PUBLIC ARTS ADVISORY BOARD STAFF REPORT

1880 Dr. Andre's Way

Meeting	File No.	Application Type
February 25, 2025	2025-015 (Bldg. 1880 Façade 1) 2025-016 (Bldg. 1880 Façade 3) 2025-017 (Bldg. 1880 Façade 6) 2025-018 (Bldg. 1880 Façade 7) 2025-019 (Bldg. 1880 Façade 8)	2025-020 (Bldg. 1880 Façade 9) 2025-021 (Bldg. 1880 Façade 10A) 2025-022 (Bldg. 1880 Façade 10 B) 2025-023 (Bldg. 1880 Façade 12)
Property Owner	Applicant /Agent	
JMS Boynton Beach	Steven Michael

Consideration of the installation of 9 murals on Building 1880 located at 1880 Dr. Andre's Way.

Building 1880 Façade 1 (File No. 2025-015)

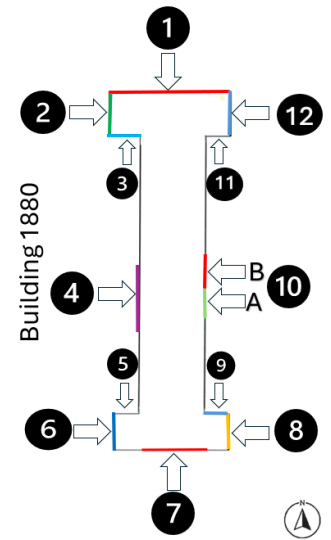
The mural features a mix of abstract patterns, geometric motifs, and a tie-dye spiral, using a bold color palette of blue, pink, purple, red, and yellow. The design is fragmented by black diagonal lines, creating a patchwork effect that visually separates the various elements. While the intent may be to introduce vibrancy, the lack of thematic cohesion results in a disjointed composition that does not contribute to a unified artistic statement.

While the mural complies with Appendix A of the LDRs, meeting the definition of public art, its execution and placement raise concerns. The upper-band location isolates the artwork from pedestrian interaction, limiting its effectiveness in enhancing the site's public-facing aesthetic. Additionally, the varying artistic styles within the mural create a fragmented appearance, lacking a clear focal point or narrative cohesion.

While the mural complies with LDR Section 8.5.3(C) regarding coverage, placement, and absence of commercial messaging, its visual impact and thematic execution remain questionable. The composition appears more decorative than conceptually driven, raising the issue of whether it effectively serves the purpose of enhancing public art within the district.

Building 1880 Façade 2 (no mural permit application submitted)

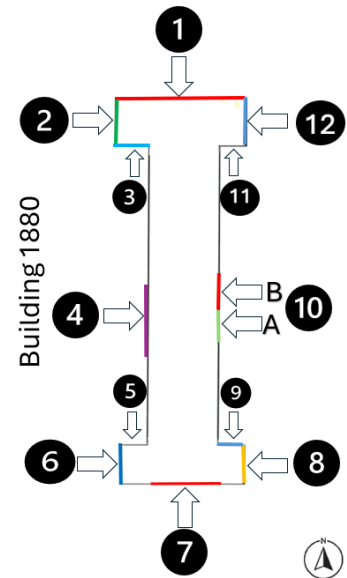
The existing mural is located on Façade 2 on the west elevation of Building 1880. No mural permit application was submitted.

Building 1880 Façade 3 (File No. 2025-016)

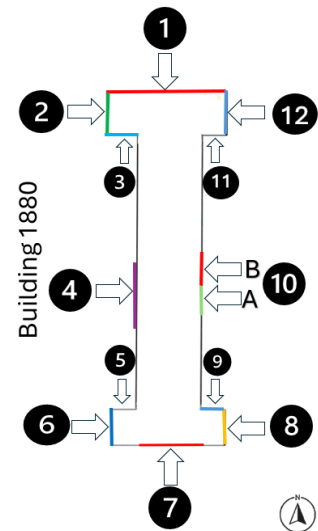
The mural on Façade 3 spans 12 feet high by 20 feet wide (240 sq. ft.), covering 100% of the west elevation of Building 1880. It features large pink floral motifs set against a solid black background, with the text "Andre Design District" prominently displayed in bold pink uppercase letters. The mural is centered around an entrance door, incorporating a minimalistic floral arrangement that

While the mural meets the general definition of public art per Appendix A of the LDRs, its integration with commercial messaging raises concerns regarding compliance with **LDR Section 8.5.3(C)(4)**, *the mural shall be predominantly pictorial, with text limited to no more than 5 percent of the proposed mural size, except for text used to create the graphic*. The “Andre Design District” text functions as identification signage rather than an artistic component, exceeding the 5% text limit established for murals. According to LDR Section 4.6.7, text within murals that serves a commercial or branding function is classified as a wall sign, requiring a separate sign permit. In this case, the mural blurs the line between artistic expression and business advertising, making it non-compliant with the mural regulations without a sign waiver.

From a design perspective, the composition is visually simplistic, relying heavily on repetitive floral imagery without a strong narrative or thematic depth. The black background, while effective in emphasizing the pink elements, creates a stark, unfinished aesthetic, especially around architectural elements like the doorway and adjacent window. The placement of the mural does not fully utilize the façade's spatial potential, leaving significant portions of the surface unadorned and contributing to a sense of incompleteness. The floral imagery, while decorative, lacks the distinctive artistic character or conceptual intent seen in more immersive public art installations.

Additionally, the condition of the mural raises concerns about long-term maintenance. The black painted façade appears to have fading and uneven wear, which may accelerate deterioration of both the background and floral elements. The proximity to an entryway also increases the likelihood of scuffing, dirt accumulation, and weathering, particularly around the door and lower portions of the mural. Without clear maintenance commitments, the artwork risks degrading quickly, impacting its overall effectiveness as a public art feature.

While the mural partially meets LDR requirements for coverage, placement, and façade integration, its commercial branding, lack of thematic depth, and maintenance concerns present significant compliance issues. The use of text exceeds allowable limits, making it functionally a sign rather than a mural, and the overall artistic execution lacks narrative cohesion or transformative impact. This raises the question of whether the mural genuinely enhances the district's creative vision or simply serves as a stylized branding tool for the development.

Building 1880 Façade 6 (File No. 2025-017)

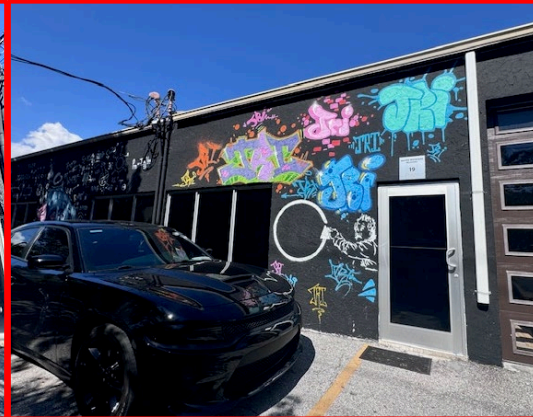
The mural on Façade 6 spans 12 feet high by 50 feet wide (600 square feet), covering 100% of the west elevation of Building 1880. It features a purple Chevrolet Impala in motion, set against a beach-inspired background with mechanical and automotive imagery. The mural includes a large transmission illustration, multiple automotive brand logos, and industrial gear motifs, creating a dynamic yet visually fragmented composition. Above the artwork, a wall-mounted sign reading "Performance Transmission" is prominently displayed.

The Performance Transmission sign is non-conforming and lacks a permit, making it a violation of the sign code under **LDR Section 4.6.7(B)**, *it shall be unlawful for any persons to post, display, change, or erect a nonexempt sign or a sign structure, that requires a permit, without first having obtained a permit therefor. Signs or sign structures erected without a valid permit shall be deemed in violation and it shall be mandatory to obtain a permit, based on this Section, or else remove the sign or sign structure.* The MROC zoning district only allows wall signs if they face a dedicated street or I-95. Since this sign does not meet either requirement, it is not permitted and must be removed. Furthermore, it does not qualify as a building sign under the code since it functions as a commercial advertisement for the automobile repair shop rather than an architectural element.

In addition to the signage violation, the mural fails to comply with the definition of a mural under Appendix A of the LDRs, which defines a mural as *"an original, one-of-a-kind unique mosaic, painting, or graphic art or combination thereof (including collage effects) that is professionally applied to aesthetically enhance the exterior of a building or accessory structure such as a dumpster enclosure, fence, or site wall, that does not contain any brand name, product name, letters of the alphabet spelling or abbreviating the name of any product, company, profession, or business, or any logo, trademark, trade name, or other commercial message."* The inclusion of automotive brand logos such as Chevrolet, Honda, Ford, Audi, and Dodge constitutes a direct violation of this definition, as murals are strictly prohibited from incorporating brand names, logos, trademarks, or commercial messaging.

According to the United States Patent and Trademark Office (USPTO), the automotive brand logos displayed on the right side of the mural are all registered trademarks. As a result, these logos must be removed from the mural as a condition of approval to ensure compliance with LDR mural regulations. Their inclusion raises concerns regarding the blurred boundary between public art and business advertising, undermining the intent of the mural ordinance.

From an artistic standpoint, the mural demonstrates technical skill, particularly in shading, reflections, and depth. However, its composition is cluttered, with competing elements—beach scenery, mechanical components, and corporate branding—lacking thematic cohesion. The coexistence of realistic and abstract styles further contributes to visual disarray, making the mural appear more promotional than expressive. The use of bright yellow, pink, and blue hues in the background creates a chaotic visual effect, which detracts from the overall quality of the piece.

The placement of the mural also presents challenges. The non-conforming sign disrupts the visual flow of the artwork, functioning more like a billboard than an integrated artistic element. The dark blue background of the sign contrasts awkwardly with the sky, creating an unintended separation that breaks the continuity of the design. Additionally, the low positioning of the artwork near the pavement makes it susceptible to wear, fading, and potential vandalism over time. The blue cloud-like outline surrounding the sign diminishes the mural's aesthetic integrity, further weakening its effectiveness as a cohesive public art installation.

Building 1880 Façade 7 (File No. 2025-018)

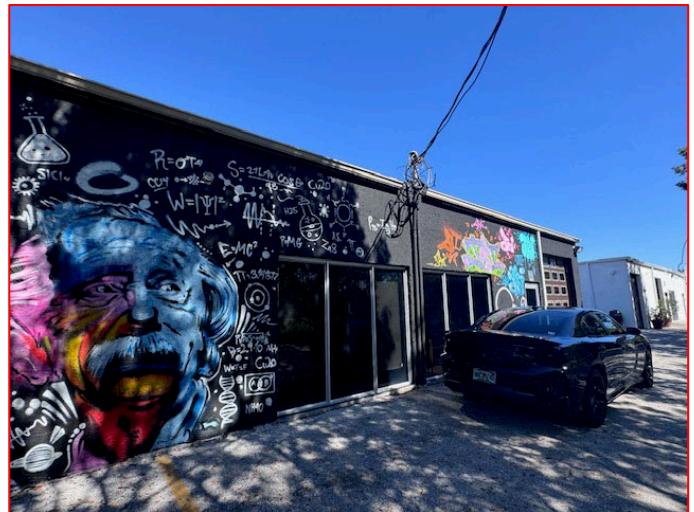
The mural on Façade 7 spans 12 feet high by 90 feet wide (1,080 square feet), covering approximately 75% of the south elevation of Building 1880. The mural prominently features a stylized portrait of Albert Einstein, rendered in a mix of blues, reds, dark and light pinks, and yellows, with a black background enhancing contrast and depth in Einstein's facial features. Surrounding the portrait are mathematical equations and scientific symbols, reinforcing his contributions to quantum mechanics and theoretical physics.

However, the right portion of the façade previously contained a graffiti-style mural featuring the letters "JRI" and various colorful graffiti tags, which were separate from the Einstein artwork. As seen in the "Before" image, the JRI mural had a distinct composition, with multiple overlapping lettering styles, bright neon colors, and a spray-paint aesthetic, making it stylistically disconnected from the Einstein mural. Since then, the "JRI" graffiti elements have been removed, but their prior existence raises questions regarding compliance and the intended artistic cohesion of the façade.

Per LDR Section 8.5.3(C)(3), *each façade is limited to one mural*, although a consistent image or theme may continue across a contiguous wall. Given the clear stylistic and thematic disconnect between Einstein's portrait and the now-removed graffiti lettering, there is a strong argument that this façade previously contained two separate murals rather than a single, unified artistic statement. If the graffiti lettering was originally considered a separate artistic installation, it should have required a separate mural permit to comply with the regulations.

While the removal of the "JRI" graffiti elements has improved thematic unity, remnants of the prior mural may still be present, requiring clarification on whether the applicant intends to repaint or restore the affected area. The Public Art Advisory Board must evaluate whether the modifications made to Façade 7 sufficiently align with the original permit request or if additional approvals are necessary.

From an artistic standpoint, the Einstein mural demonstrates a high level of technical skill, particularly in its use of color gradients, lighting effects, and expressive detailing. The mathematical notations and scientific symbols add a layer of intellectual depth, reinforcing Einstein's legacy as a physicist. However, the black background and exposed location raise concerns about long-term maintenance, as dark paint is prone to fading and accumulating dirt. The vibrant colors in Einstein's face may also be susceptible to sun exposure, requiring periodic restoration. A clear maintenance plan must be in place to ensure the mural retains its visual quality over time.

Overall, while the Einstein portion of the mural meets the artistic and thematic criteria of public art, the previous presence of the "JRI" graffiti mural raises compliance concerns. The Board must determine whether the removal of the graffiti elements sufficiently resolves the issue or if further action is needed to ensure full regulatory alignment with mural permit requirements.

Building 1880 Façade 8 (File No. 2025-019)

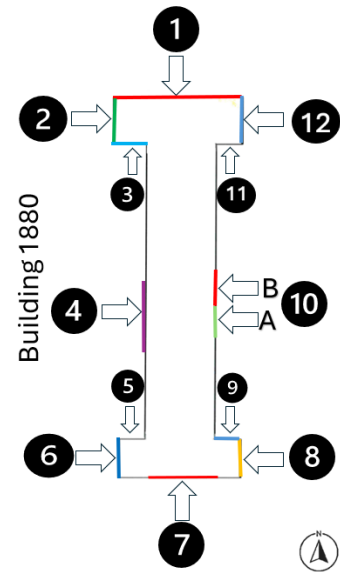
The mural on Façade 8 spans 12 feet high by 30 feet wide (360 square feet), covering 100% of the east elevation of Building 1880. The mural features portraits of four prominent historical figures, each depicted in a distinct background color—blue, pink, green, and yellow—creating a visually striking composition. The subjects appear to be individuals of great cultural and historical significance, symbolizing leadership, activism, and justice.

From an artistic standpoint, the mural demonstrates strong composition and technical skill, particularly in its use of bold color blocking and expressive brushwork to capture the likeness of each figure. The choice of vivid, contrasting colors enhances the mural's visual impact and thematic clarity, ensuring that each figure stands out while maintaining a sense of cohesion within the overall piece. The stylized rendering of facial features and clothing details contributes to the mural's recognizability and cultural depth.

However, while the mural meets artistic and regulatory standards, maintenance concerns arise due to its exposed location and bold color palette. The intensity of the colors may be susceptible to fading, particularly under direct sunlight, which could diminish the mural's vibrancy over time. Additionally, the paint application appears to extend around building elements such as pipes and window edges, which may result in wear and inconsistencies if the mural is not properly sealed or maintained.

Building 1880 Façade 9 (File No. 2025-020)

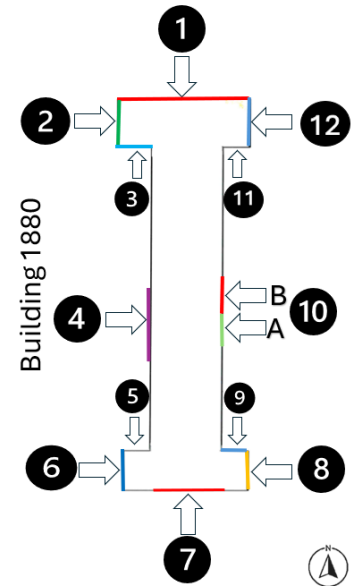
The mural on Façade 9 spans 12 feet high by 20 feet wide (240 square feet), covering 100% of the east elevation of Building 1880, located on the south portion of the building facing north. The artwork consists of a combination of abstract patterns, digital-inspired graphics, and text elements on a black background, incorporating symbols, graphs, flowcharts, and interconnected nodes that resemble social media networks, digital interaction, and technological themes.

While the mural presents an intriguing visual approach, its composition appears fragmented, lacking a clear focal point or cohesive artistic narrative. The scattered arrangement of symbols and text results in a disorganized aesthetic, making it challenging to interpret as a unified artistic expression. The inclusion of words such as "Interaction," "Identity," "Subscribers," and "Rank Social" raises concerns regarding potential thematic ambiguity, as the mural blurs the line between conceptual art and informational design.

Per LDR Section 8.5.3(C)(3), each façade is limited to one mural, and while this piece appears to be a single composition, the varied design elements and scattered text create an unstructured visual hierarchy, potentially diminishing its effectiveness as a public art installation. Additionally, the text components must comply with LDR Section 8.5.3(C)(4), which limits text in murals to no more than 5% of the overall mural size, unless incorporated as part of a graphic design. The prominent use of words and labels throughout the mural may exceed this limit.

From a technical perspective, the use of a black background raises durability concerns, as dark colors are prone to fading, accumulating dirt, and showing signs of wear more quickly than lighter hues. The presence of detailed line work and small-scale text elements further increases the risk of deterioration, particularly in high-exposure areas. Without a structured maintenance plan, portions of the mural may fade unevenly, compromising its readability and artistic impact.

Overall, while the mural aligns with the definition of public art under Appendix A of the LDRs, its lack of a cohesive composition, potential text compliance issues, and long-term durability concerns warrant further evaluation by the Public Art Advisory Board. The Board should assess whether modifications are necessary to enhance the mural's thematic clarity, ensure text compliance, and establish a maintenance strategy that preserves the integrity of the artwork over time.

Building 1880 Façade 10A (File No. 2025-021)

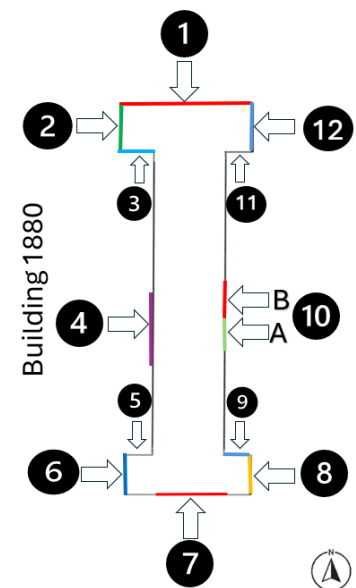
The mural on Façade 10A spans 12 feet high by 5 feet wide, with an additional 8 feet by 5 feet section above a window (100 square feet total), covering 100% of the east elevation of Building 1880. The "Before" image of the mural featured a prominent symbolic eye with colorful detailing, surrounded by various inspirational hashtags and phrases promoting self-love, empowerment, and positivity. The background consisted of a pastel gradient, blending pink, teal, and white tones to create a visually soft yet impactful message.

The "After" image shows significant alterations to the façade, with most of the previous mural removed or painted over in a muted blue tone. The eye motif remains faintly visible, but the text-heavy content and hashtag phrases have been eliminated. The visual impact of the façade has been greatly reduced, shifting from a message-driven artistic piece to a more subdued color transition with minimal remaining design elements.

Per LDR Section 8.5.3(C)(4), *text within a mural shall be predominantly pictorial, with written elements limited to no more than 5% of the overall mural size, except for text incorporated as a graphic element.* The "Before" version of this mural likely exceeded this limitation, as the hashtags and phrases dominated the composition, making the façade more of a message board than a pictorial mural. The removal of the text components in the "After" image aligns the artwork more closely with mural regulations, ensuring compliance with the LDR.

From a design perspective, the original mural featured a clear theme centered on personal empowerment and positivity, with text playing a dominant role in conveying the message. However, its text-heavy nature and reliance on hashtags may have contributed to a commercialized or promotional aesthetic, blurring the line between public art and branding. The simplified "After" version, while compliant, now appears incomplete and lacks the previous vibrancy and thematic clarity.

Overall, the modifications to Façade 10A have addressed prior compliance issues related to text size and mural definition. However, the altered version now lacks the thematic impact of the original, and its partial removal raises questions about the intended final state of the façade. The Board may need clarification on whether this façade is considered finalized or if further mural work is planned to ensure artistic and regulatory alignment.

1. The mural is 100 SF, 8' by 5' above window, 12' by 5'
2. Mural maintenance plan:
3. The text has been removed.
4. The test has been removed.
5. See 2.
5. Biography of the artist: As a passionate, exploratory

Building 1880 Façade 10B (File No. 2025-022)

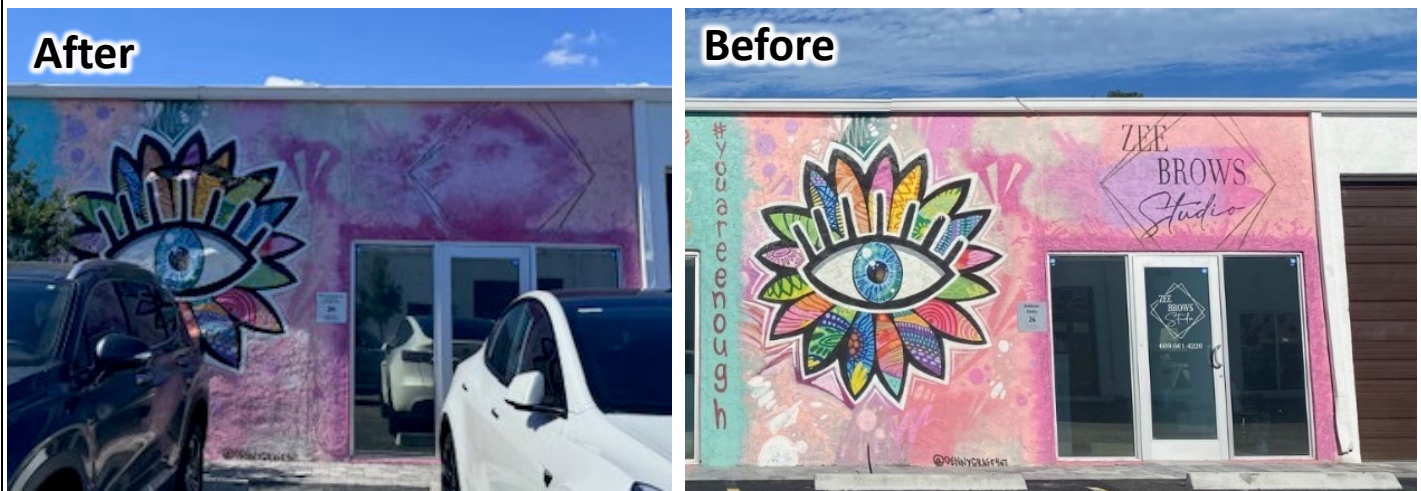
The mural on Façade 10B spans 12 feet high by 20 feet wide (240 square feet), covering 100% of the east elevation of Building 1880. The "Before" image showcases a bold, colorful eye symbol within a lotus-like design, accompanied by text elements, including

"ZEK BROWS Studio" and the phrase "#youareenough". The background is a gradient of pink and teal tones, incorporating soft abstract textures and faint images of faces within the design.

The "After" image reveals a significant reduction in mural content, with the studio branding and much of the text removed. The eye design remains, but it appears more faded, and the background has been muted, leaving only faint traces of the previous artwork. The erasure of text and branding elements aligns the mural with regulatory requirements but also results in a loss of vibrancy and thematic clarity.

Per LDR Section 8.5.3(C)(4), *text within a mural shall be predominantly pictorial, with written elements limited to no more than 5% of the overall mural size, except for text incorporated as a graphic element.* The "Before" version likely exceeded this threshold, as both hashtags and business-related text were dominant features. The removal of commercial references ensures compliance with mural regulations, as business signage must be reviewed under LDR Section 4.6.7, which governs signage regulations separately from murals.

The altered mural now appears faded and incomplete, raising aesthetic concerns regarding its maintenance and artistic integrity. The remaining elements lack the boldness and definition of the original piece, making it unclear whether this is a final iteration or if additional refinements are intended. The faint outlines of the former design suggest an incomplete removal, which may require further intervention to either restore the remaining artwork or repaint the façade entirely.

From a technical standpoint, the pastel background is highly susceptible to fading and weather-related wear, particularly given its prominent exposure. The inconsistent fading and residual ghosting of the prior design create an unfinished appearance, which could diminish the overall aesthetic quality of the building's exterior. The lack of a clear preservation plan for the altered mural may result in further deterioration, necessitating a defined maintenance strategy to prevent further decline.

Overall, while the removal of non-compliant text and branding elements ensures LDR compliance, the resulting mural appears diminished in both impact and artistic execution. The Public Art Advisory Board may need clarification on whether the current version is final or if additional restoration efforts are planned to enhance cohesion, durability, and visual appeal.

Building 1880 Façade 12 (File No. 2025-023)

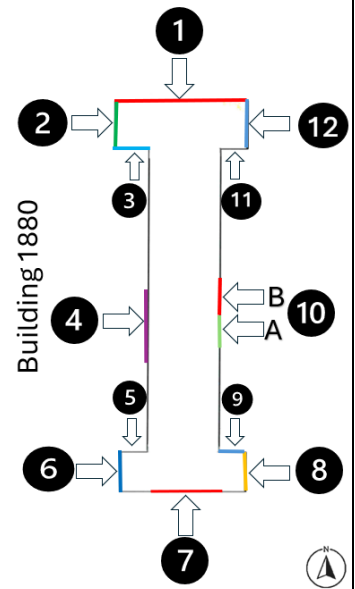
Per LDR Section 8.5.3(C)(3), *each façade is limited to one mural*, though a consistent image or theme may continue across contiguous walls. This mural qualifies as a single, cohesive artistic statement, successfully integrating multiple cultural and historical references into one narrative of unity and resilience. However, the noticeable deterioration raises concerns regarding maintenance and longevity, which must be addressed per LDR Section 8.5.3(C)(7), requiring a preservation and maintenance plan to ensure the mural retains its integrity.

Additionally, LDR Section 8.5.2(A)(4) requires public art to be of exceptional quality and enduring value. While the original execution demonstrated a high level of artistry, the current condition suggests inadequate maintenance, which could diminish its intended long-term cultural and aesthetic contribution. The Public Art Advisory Board may need further clarification on restoration efforts or protective measures planned to prevent further degradation.

From a technical standpoint, the vivid color palette and intricate details require a stable surface and proper protective coatings to prevent fading, chipping, and weather-related wear. Without proactive upkeep, the mural risks further loss of detail and artistic impact over time. The Board should assess whether the existing maintenance plan is sufficient or if additional measures, such as resealing and periodic touch-ups, should be mandated.

Overall, while the mural on Façade 12l meets artistic and thematic criteria for public art, its current state of deterioration raises significant maintenance concerns. The Board must determine whether restoration efforts should be required to preserve its cultural significance, artistic integrity, and compliance with mural preservation standards.
